Lorie Cahn, P.G.
P.O. Box 3669
Jackson, WY 83001-3669
307-733-9396 (phone)
307-690-5307 (cell)

June 23, 2015

Subject: Comments on Proposed Revisions to Water Quality Rules and Regulations Chapter 25

Soil Texture Determination Flowchart (Table B-2 in Idaho's Technical Guidance Manual https://www.deq.idaho.gov/media/1148/tgm-entire.pdf)

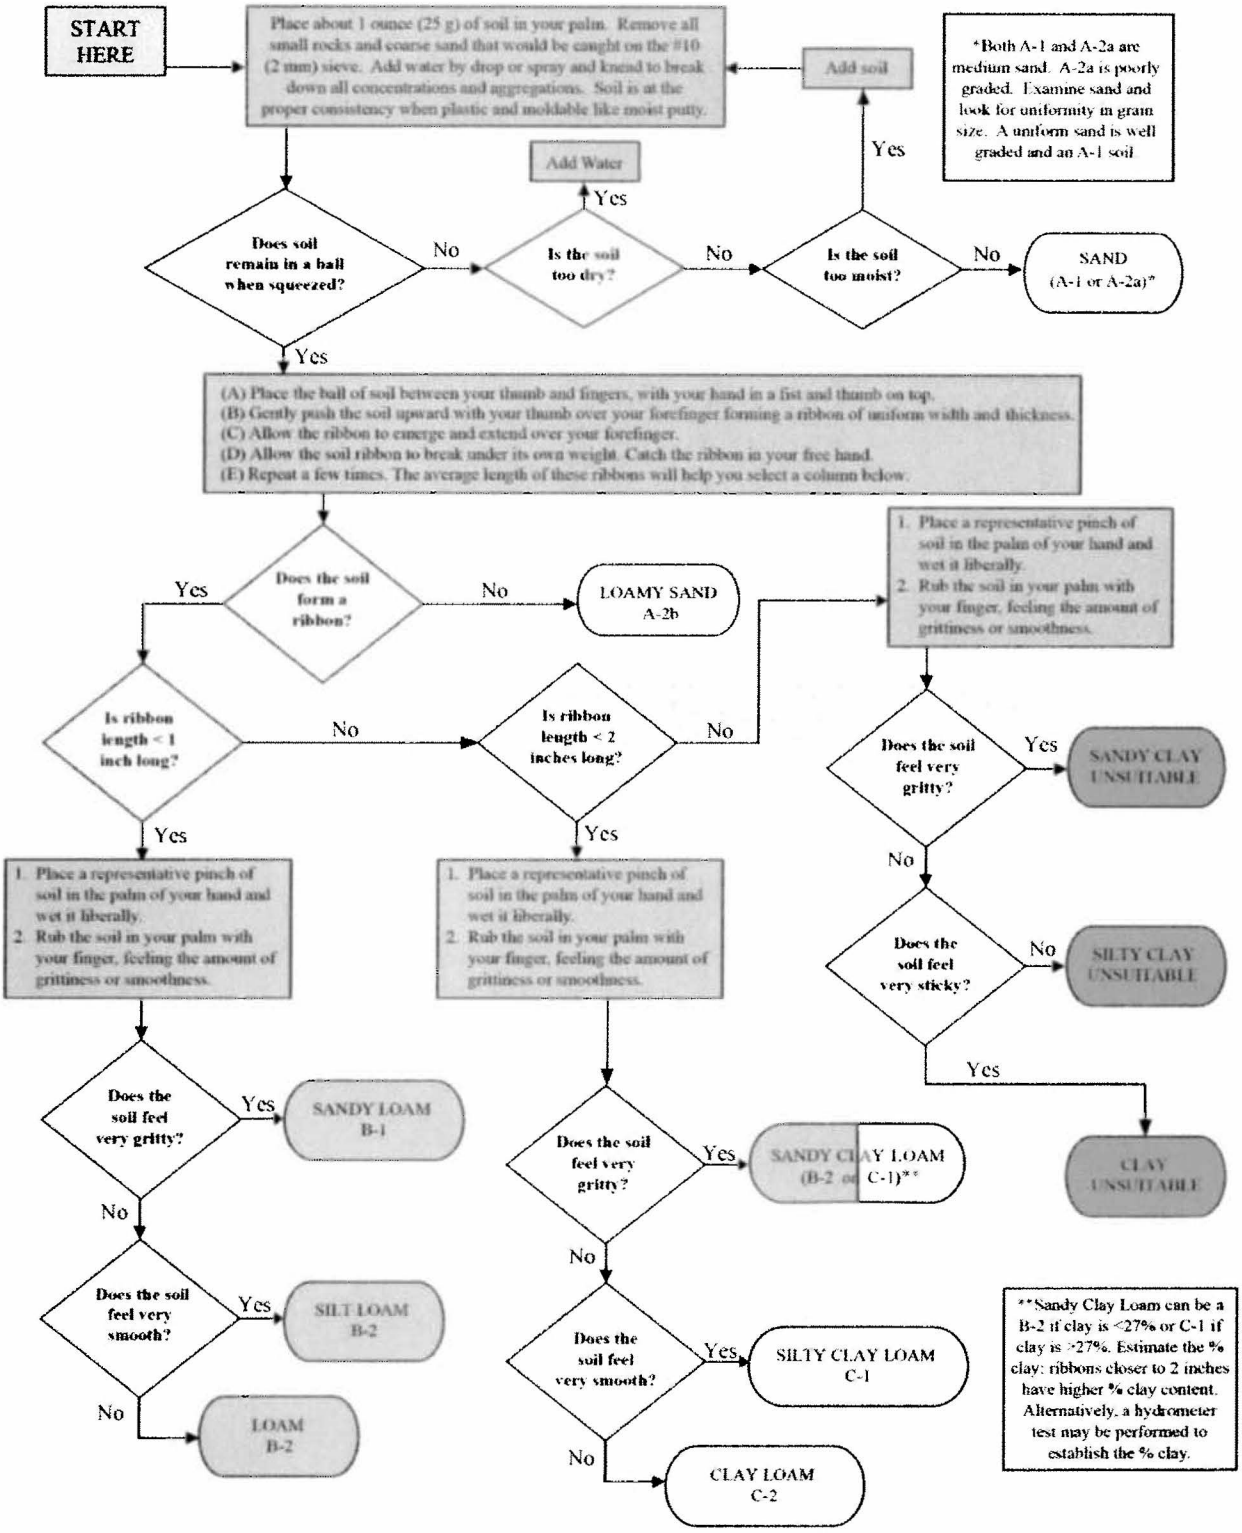
Because percolation tests results are variable and the results often inaccurate, an alternative suggested at WWAB meetings is to determine soil texture using simple methods that involve nothing more than mixing soil with water and testing by kneading, squeezing, and rubbing with the hands and answering simple questions regarding whether a ribbon can be made and is the soil gritty, etc. A simple table then equates soil texture to percolation rates. An example is shown on the next two pages used by the State of Idaho that was adopted from the U.S. Department of Agriculture.
